Inland Transport Committee

World Forum for Harmonization of Vehicle Regulations

Tyres: Regulation No. 117 (Tyre rolling resistance, rolling noise and wet grip)

Proposal for a Supplement to the 02 series of amendments to UN Regulation No. 117

~~Example of~~ Examples of separate Regulation No. 117 approval marks

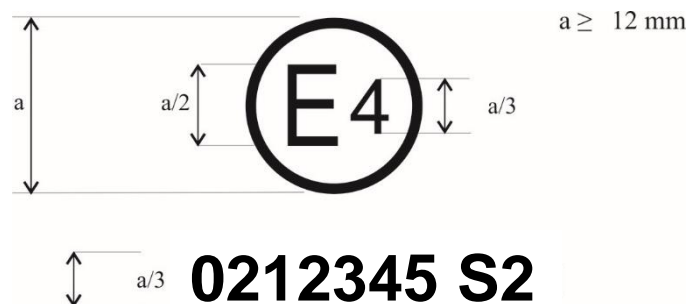
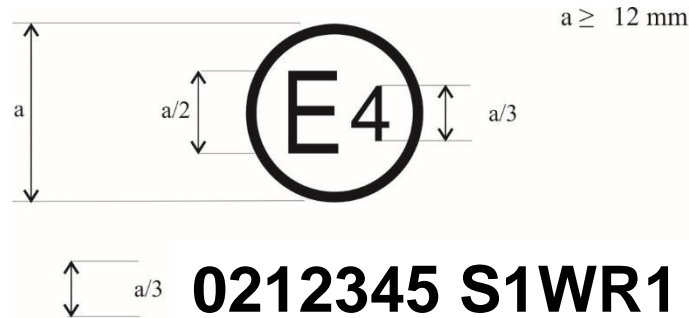
Annex 2 - Appendix 1, amend to read:

The above approval mark, affixed to a tyre shows that a tyre concerned has been approved in the Netherlands (E 4) pursuant to Regulation No. 117 (marked by "S2"~~(rolling sound at stage 2)~~ only), under approval number 0212345. **This indicates that the approval is for rolling sound at stage 2 (S2).** The first two digits of the approval number (02) indicate

that the approval was granted **in accordance with this Regulation which included according to the requirements** 02 series of amendments ~~to this Regulation.~~

The above approval mark shows that the tyre concerned has been approved in the Netherlands (E 4) pursuant to Regulation No. 117 (marked by "S1WR1") ~~(rolling sound at stage 1) W (wet adhesion), and R1 (Rolling resistance at stage 1)~~ under approval number 0212345. This indicates that the approval is for **rolling sound at stage 1 (S1), wet adhesion (W) and rolling resistance at stage 1 (R1)** ~~S1WR1~~. The first two digits of the approval number ("02") indicate that the approval was granted **in accordance with this Regulation which included according to the requirements** of the 02 series of amendments ~~to this Regulation.~~

Approval according to Regulation No. 117 coincident with approval of Regulation No. 30 or 54[‡]

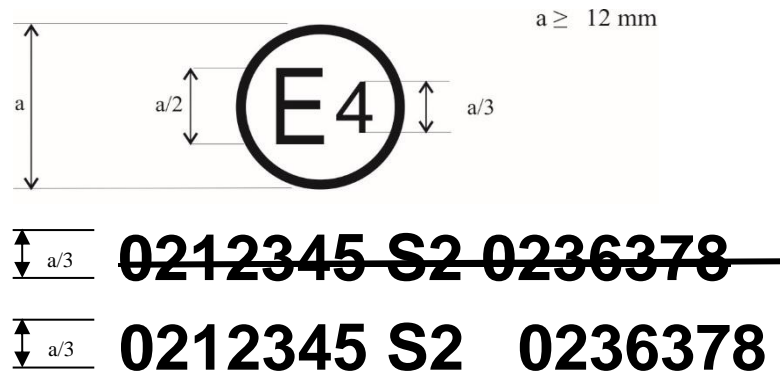
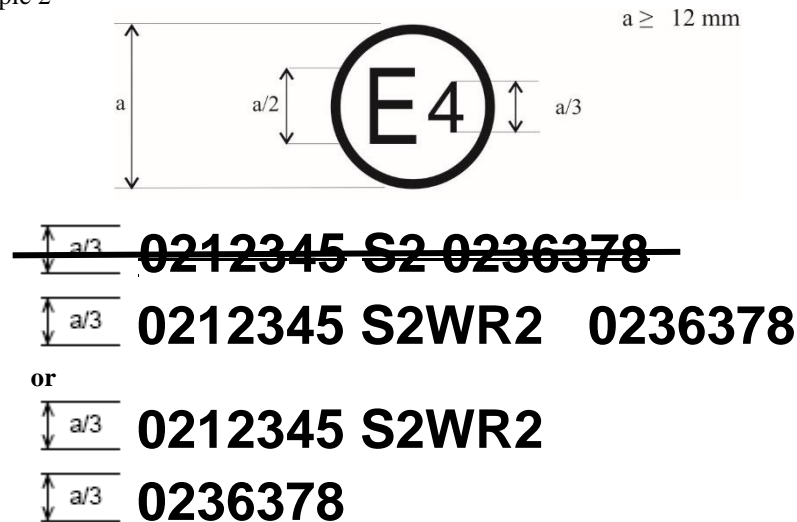
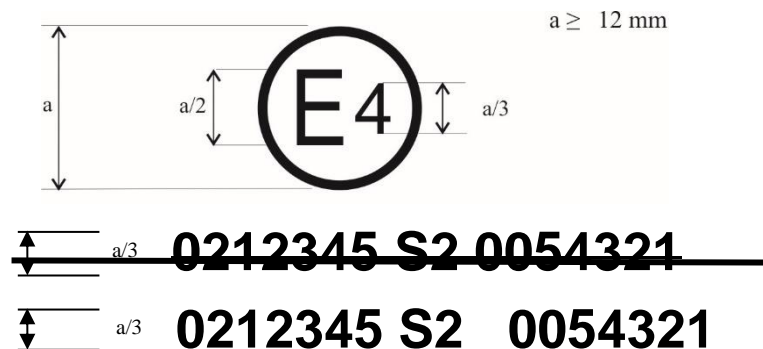
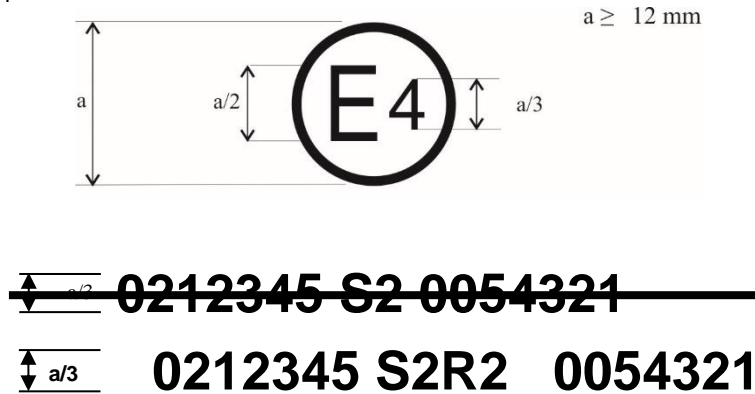
Annex 2 - Appendix 2, remove footnote 1 amend to read:

The above approval mark shows that the tyre concerned has been approved in the Netherlands (E 4) pursuant to Regulation No. 117 (marked by "S2" ~~(rolling sound at stage 2)~~), under approval number 0212345 and Regulation No. 30, under approval number 0236378. **This indicates that the approval is for rolling sound at stage 2 (S2).** The first two digits of the approval number ("02") **in conjunction with "S2"** indicate that the approval was granted **in accordance with Regulation No. 117 which included according to the 02 series of amendments. The first two digits of and the Regulation No. 30 approval number ("02") indicate that this Regulation included the 02 series of amendments.**

The above approval mark shows that the tyre concerned has been approved in the Netherlands (E 4) pursuant to Regulation No. 117 (marked by "S2WR2" (~~rolling sound at stage 2 wet adhesion and rolling resistance at stage 2~~)), under approval number 0212345 and Regulation No. 30, under approval number 0236378. **This indicates that the approval is for rolling sound at stage 2 (S2), wet adhesion (W) and rolling resistance at stage 2 (R2).** The first two digits of the approval number ("02") **in conjunction with "S2WR2"** indicate that the **first approval was granted in accordance with Regulation No. 117 which included according to the 02 series of amendments. The first two digits of and the Regulation No. 30 approval number ("02") indicate that this Regulation included the 02 series of amendments.**

The above approval mark shows that the tyre concerned has been approved in the Netherlands (E 4) pursuant to Regulation No. 117 and the 02 series of amendments under approval number 0212345 (marked by "S2"), and Regulation No. 54, **under approval number 0054321**. This indicates that the approval is for rolling sound stage 2 (S2). The first two digits of the Regulation No. 117 approval number ("02") in conjunction with "S2" indicate that the first approval was granted in accordance with Regulation No. 117 which included the 02 series of amendments. The first two digits of **the Regulation No. 54 approval number ("00")** indicate that this Regulation was in its original form.

The above approval mark shows that the tyre concerned has been approved in the Netherlands (E 4) pursuant to Regulation No. 117 and the 02 series of amendments under approval number 0212345 (marked by "~~S2R2~~"-~~S2 R2~~), and Regulation No. 54, **under approval number 0054321**. This indicates that the approval is for rolling sound stage 2 (S2) and rolling resistance stage 2 (**R2**). The first two digits of the Regulation No. 117 approval number ("02") in conjunction with "S2R2" indicate that the first approval was granted in accordance with Regulation No. 117 which included the 02 series of amendments. The first two digits of **the** Regulation No. 54 **approval number** ("00") indicate that this Regulation was in its original form."

Combinations of markings of approvals issued in accordance with ~~UN~~ Regulations Nos. 117, 30 or 54

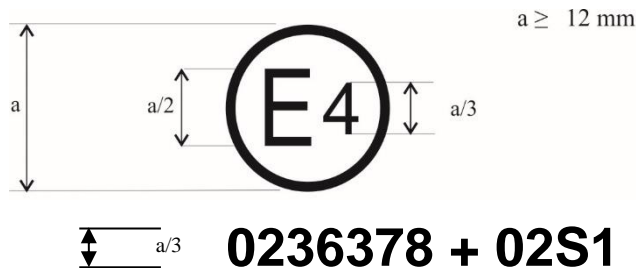
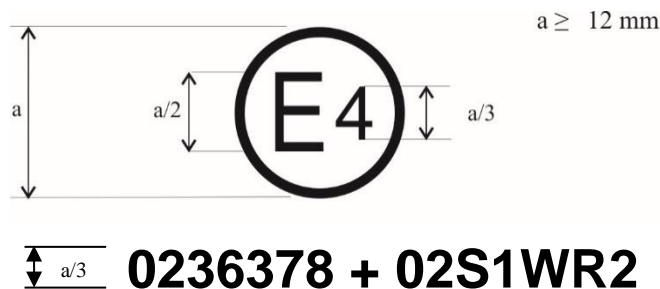
Annex 2 - Appendix 3, amend to read:

The above approval mark shows that the tyre concerned has been approved in the Netherlands (E 4) pursuant to ~~UN~~ Regulation No. 30 according to its 02 series of amendments (indicated by the first two digits of the approval number, "02") under approval number 0236378. It is also marked by "+ 02S1" which indicates that the tyre was also approved pursuant to ~~UN~~ Regulation No. 117 (02 series of amendments) for rolling sound at stage 1.

The above approval mark shows that the tyre concerned has been approved in the Netherlands (E 4) pursuant to Regulation No. 30 according to its 02 series of amendments (**indicated by the first two digits of the approval number, "02"**) under approval number 0236378. It is also marked by "+ 02S1WR2" which indicates that the tyre was also approved pursuant to ~~UN~~ Regulation No. 117 (02 series of amendments) for S1 (rolling sound at stage 1), W (wet adhesion) and R2 (rolling resistance at stage 2)."

Extensions to combine approvals issued in accordance with Regulation No. 117[†]

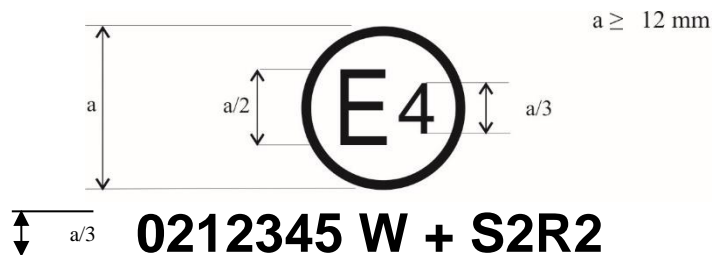
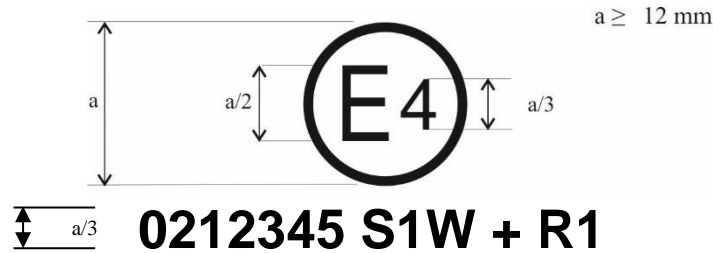
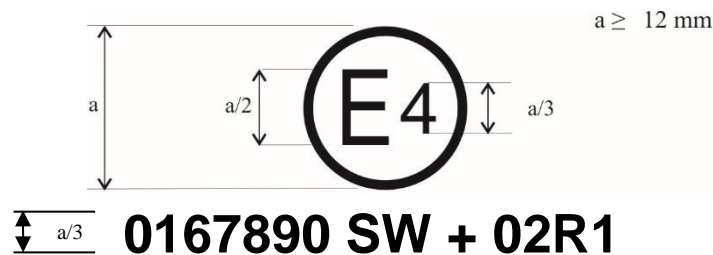
Annex 2 - Appendix 4, remove footnote 1 amend to read:

The above approval mark shows that the tyre concerned has been initially approved in the Netherlands (E 4) pursuant to Regulation No. 117 ~~according to its and the~~ 02 series of amendments (**indicated by the first two digits of the approval number, "02"**) under approval number 0212345 (**marked by "W"**). This indicates that the approval is for W (wet ~~grip~~ ~~adhesion~~). The "S2R2" preceded by "+" indicates that it ~~has had~~ its approval **has been** extended under Regulation No. 117 to rolling sound at stage 2 and rolling resistance at stage 2 based on separate certificate(s).

[†] ~~Approvals in accordance with Regulation No. 117 for tyres within the scope of Regulation No. 54 currently do not include wet adhesion requirements.~~

The above approval mark shows that the tyre concerned has been initially approved in the Netherlands (E 4) pursuant to Regulation No. 117 ~~according to its~~ ~~and the~~ 02 series of amendments (**indicated by the first two digits of the approval number, "02"**) under approval number 0212345 (**marked by "S1W"**). This indicates that the approval is for S1 (rolling sound at stage 1) and W (wet ~~grip~~ ~~adhesion~~). The "R1" preceded by "+" indicates that ~~it has had~~ its approval **has been** extended under Regulation No. 117 to rolling resistance at stage 1 based on separate certificate(s).

The above approval mark shows that the tyre concerned has been initially approved in the Netherlands (E 4) pursuant to Regulation No. 117 ~~according to its~~ ~~and the~~ 01 series of amendments (**indicated by the first two digits of the approval number, "01"**) under approval number 0167890 (**marked by "SW"**). This indicates that the approval is for S (rolling sound at stage 1) and W (wet ~~grip~~ ~~adhesion~~). The "02R1" preceded by "+" indicates that ~~it has had~~ its approval **has been** extended under Regulation No. 117 ~~according to its~~ ~~and the~~ 02 series of amendments to rolling resistance at stage 1 based on separate certificate(s).
